COUNCIL SUPPLEMENTARY ASSESSMENT REPORT

SYDNEY EASTERN CITY PLANNING PANEL

PANEL REFERENCE & DA NUMBER	PPSEC-281 – [DA/168/2023]
PROPOSAL	Demolition (220 space car park) and construction and use of five (5) buildings for mixed uses including student accommodation, UNSW university space, retail, communal and publicly accessible open space (West Mall), and basement car parking. Amended plans received increasing the width of the northern easement by setting back further buildings C and D, providing within the easement a B99 Turning circle at western rear end and options for Pick-up Drop-off (PUDO).
ADDRESS	Lot 2 DP 1173179 [215B Anzac Parade]
APPLICANT	Clare Hall - UNSW
OWNER	University of New South Wales
DA LODGEMENT DATE	11 May 2023
APPLICATION TYPE	CROWN DA
REGIONALLY SIGNIFICANT CRITERIA	Section 2.19(1) and Clause 4 of Schedule 6 of State Environmental Planning Policy (Planning Systems) 2021 declares the proposal regionally significant development as the development has a cost of works greater than \$5m.

Figure 3: Amended Northern easement changes show increased setback of building C to 10m, building D to 13.4m and B99 Turning circle.

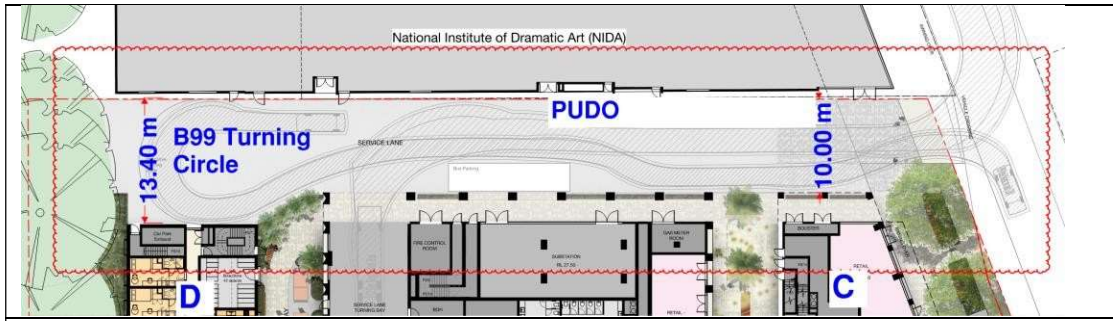
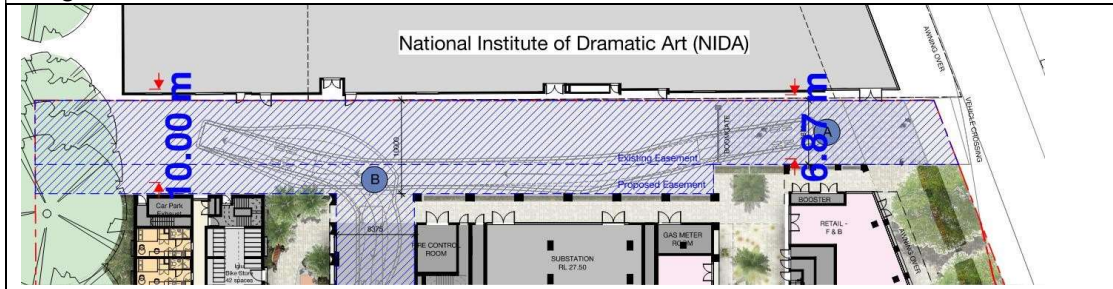
The sole plan amendments relate to the shifting of building C and D further south increasing their setbacks to 10m and 13.4m respectively and including a B99 Turning circle at the western (rear) part of the easement resulting in the changes in the development data shown in table 1 further below.

The applicant submitted amended plans on 27 August 2024 showing an increase of the Building D footprint from the northern boundary from 10m to 13.4m. Colston Budd Rogers and Kafes have reviewed the amended setback and provided acknowledgement that the easement contains a right of way that allows a car to turn around at the western end of the right of way. Council's Traffic Engineer has also reviewed and confirm no further issues in relation to the turning circle and its ability to accommodate the B99 turning circle.

The deferral issue required canvassing of Building C footprint to be increased to be in line with Building B inclusive of a 3m deep colonnade. The applicant's amended plans as indicated in **Figures 1 and 2** show that the whole of building C is setback 10m from the northern boundary and that a 3m wide colonnade is provided in line with the colonnade at the rear of building B along the ground level.

Figures 5: The figures below shows in street view the easement crossover and area of the easement extension preferred by NIDA. The street view image also shows the location of the bus stop in proximity to the southern edge of the existing crossover.

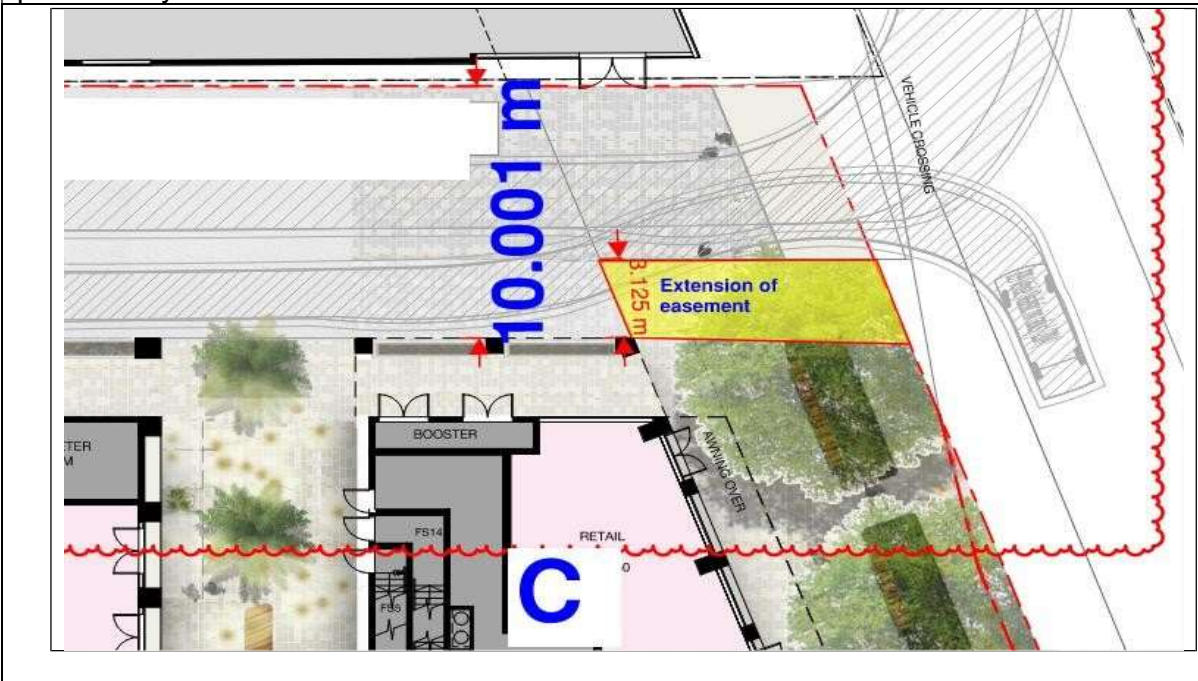
- *A 10m easement width for the entire length of the easement except where widened to accommodate a car turning bay and service turning bay. Removal of the landscaped area at the eastern end of the easement and replacement with paving or concrete to enable vehicles to travel over the area.*

Assessment Officers' comment: The main purpose of this change is to enable an extension of the easement at the north-east of building C in the yellow shaded area of the **Figure's 5 and 6** below. No objections are raised by Council in relation to this amendment as it enables a larger swept path for HRV vehicles and semi-trailers entering and/or exiting the site. A suitable condition is included to enable widening of the easement in this part of the site.
